**SITE PLAN REVIEW SHEET
ENVIRONMENTAL VARIANCE REQUEST ONLY**

CASE: SP-2018-0579C.SH

PROJECT NAME: Persimmons

DESCRIPTION OF VARIANCE:

DETENTION POND PLAN

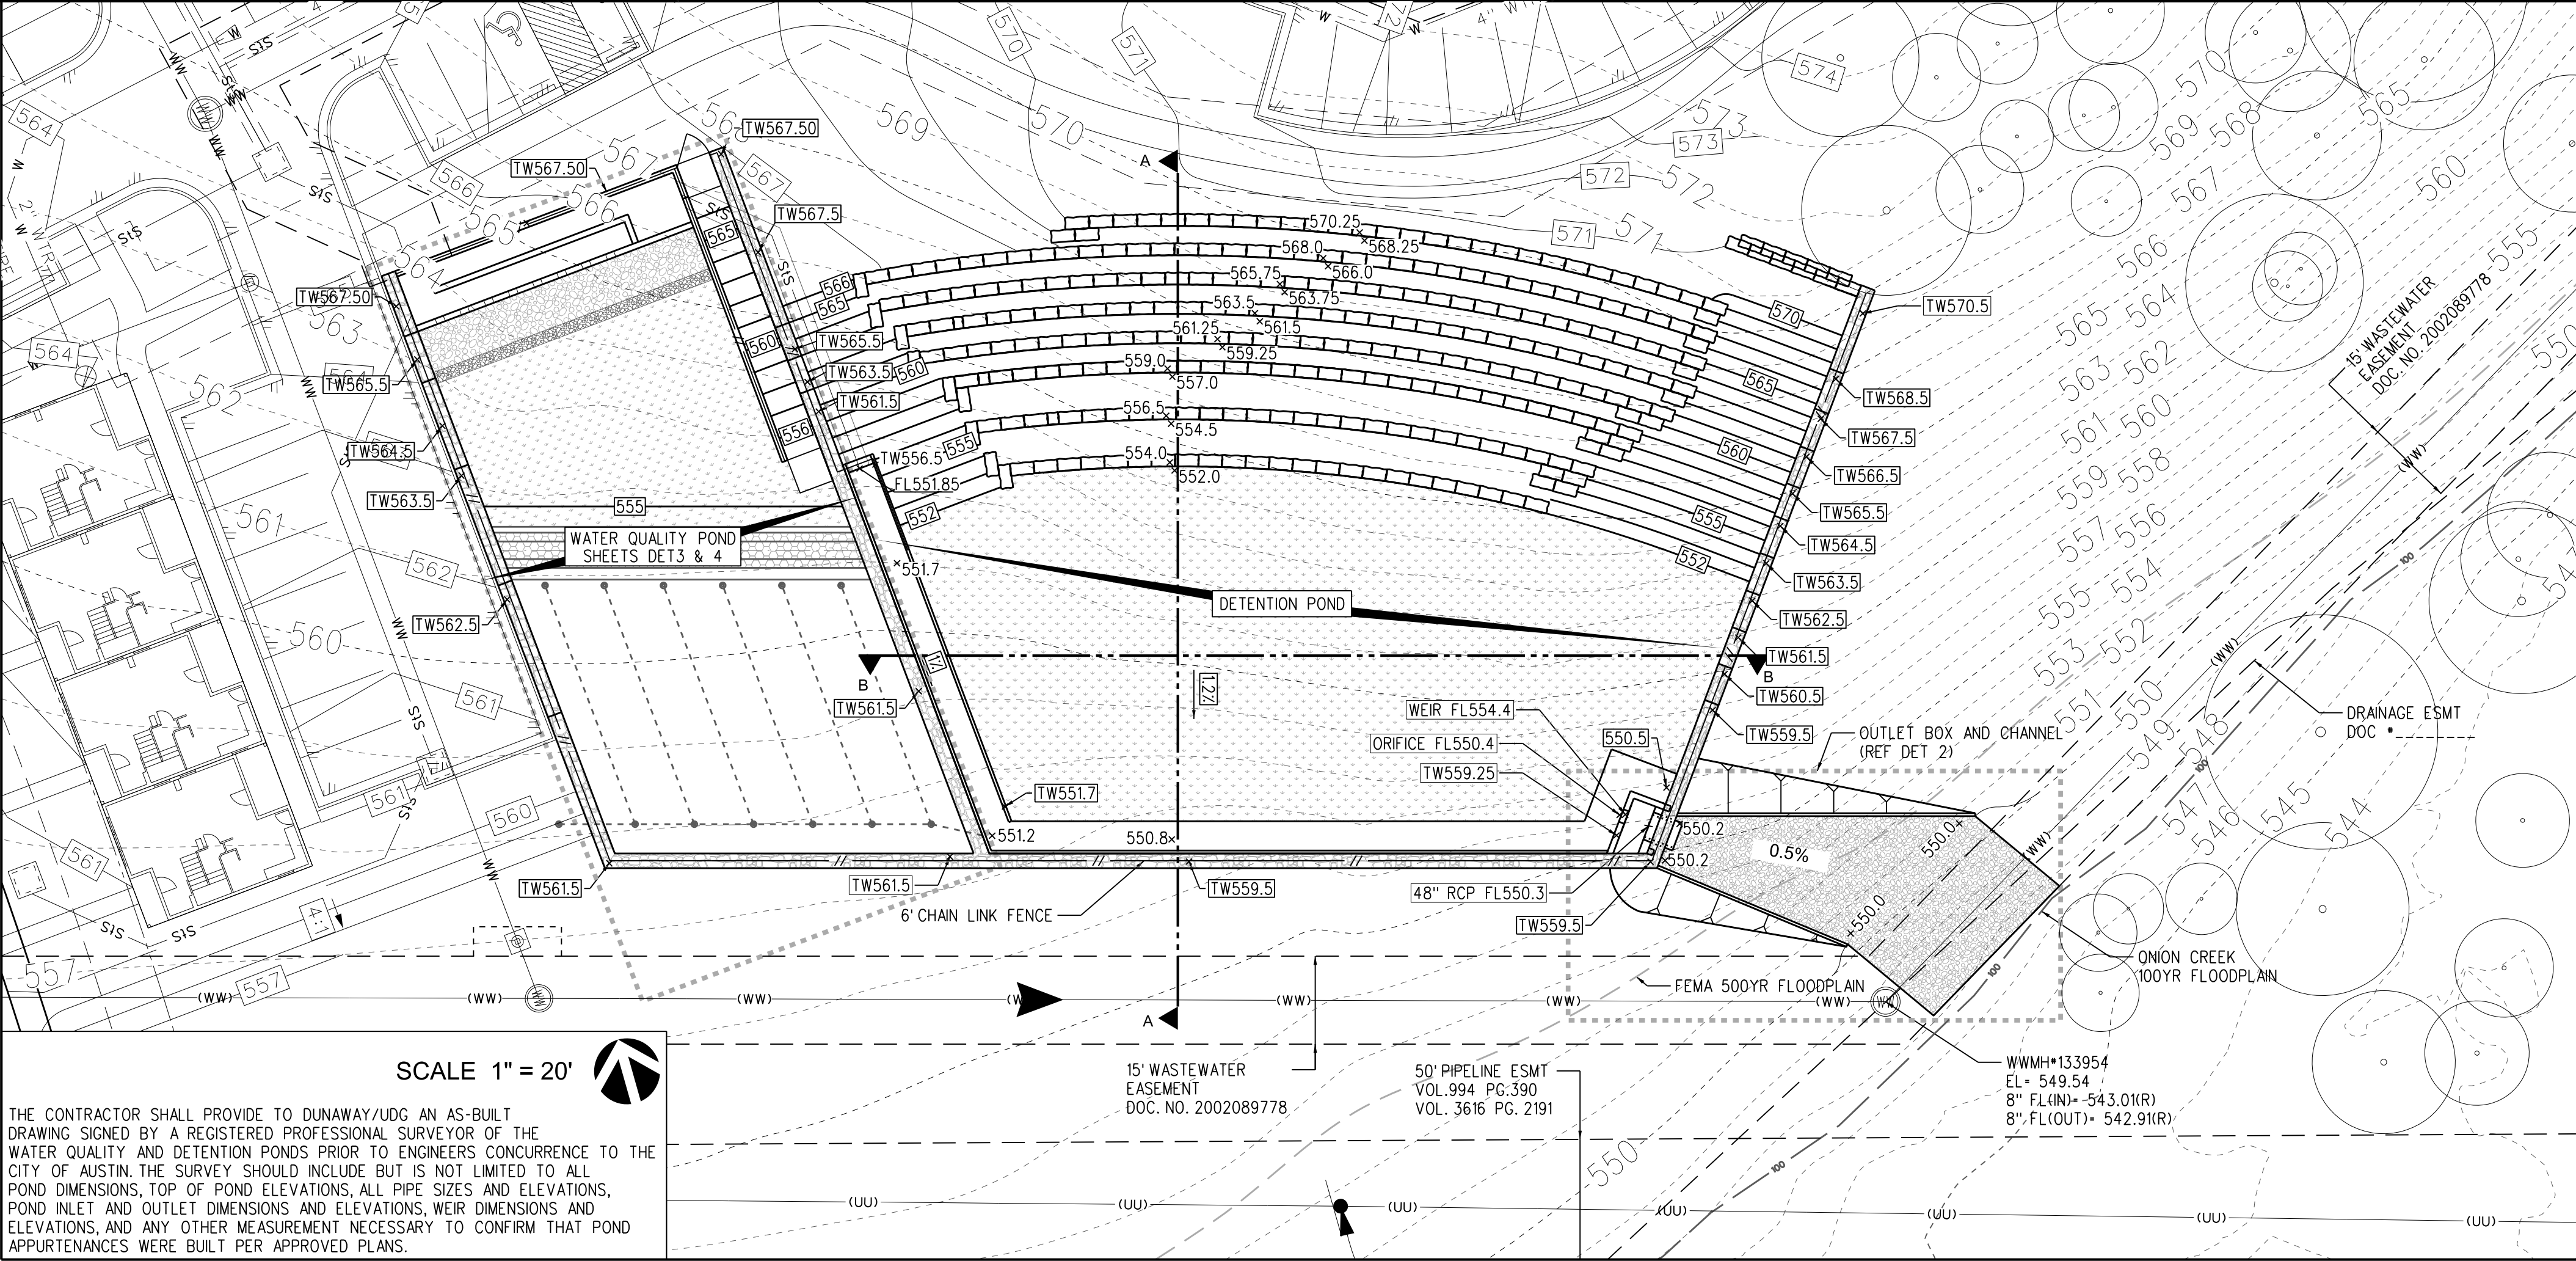
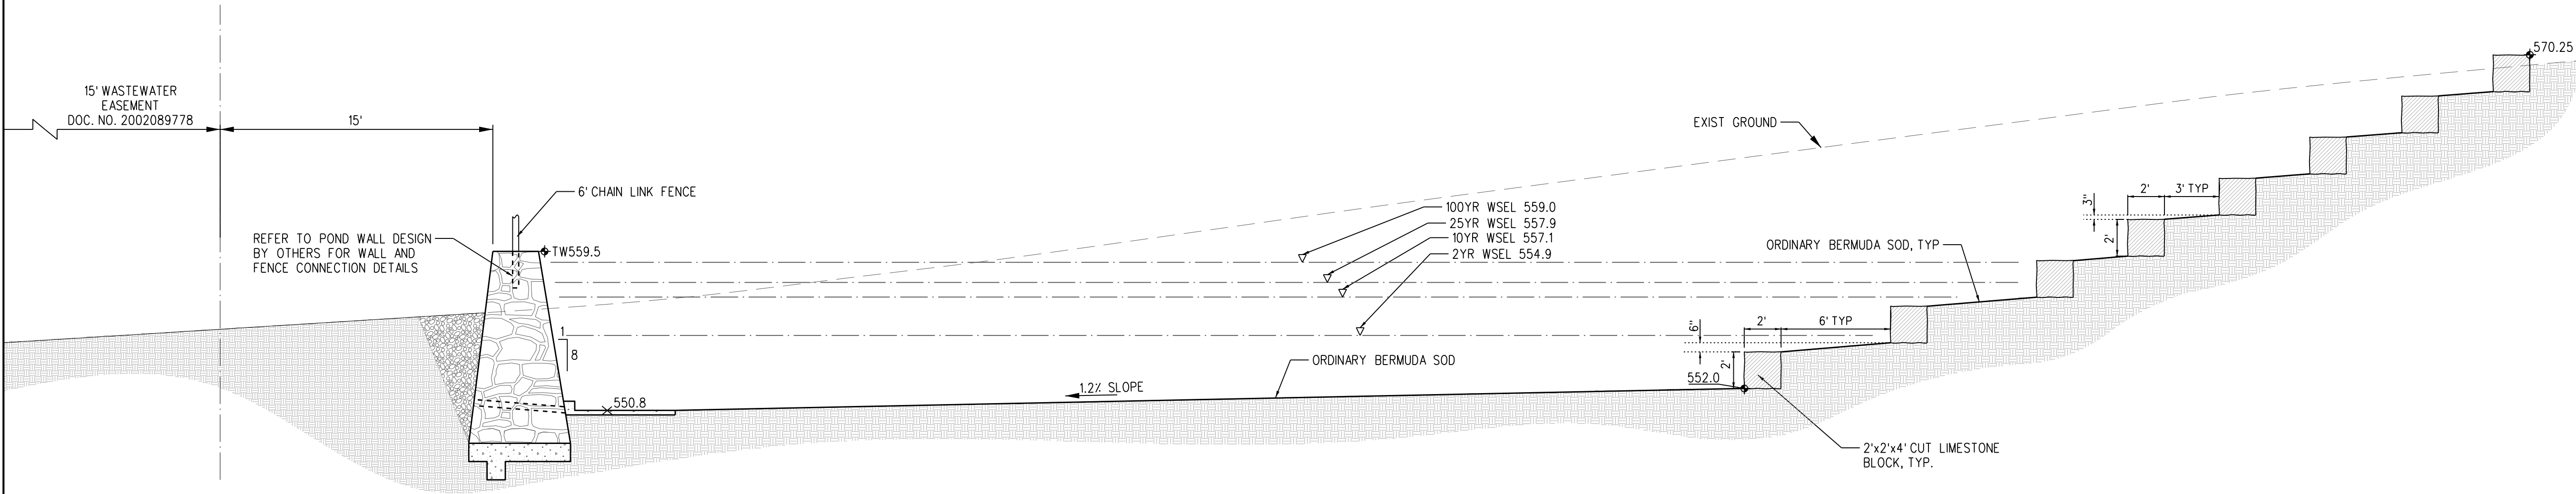
- The location and footprint of the pond avoids any conflict with the existing wastewater lines at the southern end of the property;
- The pond design will make a vertical cut in the slopes and reinforce the cut side with a concrete trapezoidal wall with stone veneer (see Pond Section in exhibit labeled Detention Pond Plan, page 20); and,
- The pond takes advantage of the natural slope of the land, and by locating the pond in this proposed location, the project does not seek to significantly alter the existing drainage patterns.

- Revegetate the top and backside of the detention pond berm with native, deep-rooted bunch grasses; and,
- Provide additional tree protection for trees 4-8” in diameter located east of the proposed pond along the steeper slopes.
